ROARING FORK VALLEY HORSE COUNCIL

8/7/2022

To the TOSV Town Council and Planning Commissioners -

TOSV Town Council met Monday evening July 25th, for the Town Park Regulatory public hearing, ordinance #5-22 – First Reading. They heard from many concerned Village residents and Roaring Fork Valley locals regarding the precious wetlands area within the Town Park and the 47-year-old Snowmass Rodeo.

Above is the new approved plan for the Town Park / Snowmass Rodeo design.

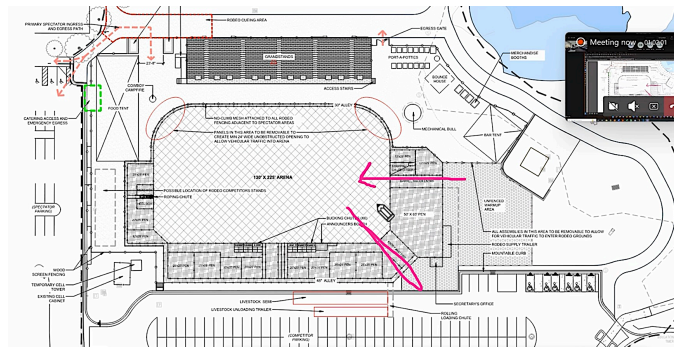
How will Brush Creek water, entering from the golf course through the culvert, be filtered before it enters the man-made pond?

How will the proposed retention area capture and clean Brush Creek water, if waterflow is below the retention area?

If the larger man-made pond was originally constructed to act as a filter for water coming from Brush Creek, identified by Roaring Fork Conservancy as an “urban stream”, how will building an additional area for the same purpose benefit Snowmass village?

Will Brush Creek water coming through the culvert and under the bridge need to be pumped up to the retention area at Town Park?

Will the retention area have to be excavated to a lower level in order to take the water?

Will excavation costs for lowering the retention area or pumping water up into the retention area be cost prohibitive?

The contestant parking area is insufficient and RFVHC considers this a major safety issue. Equestrian rodeo parking could utilize this higher ground, retention area space and general parking would benefit as well.
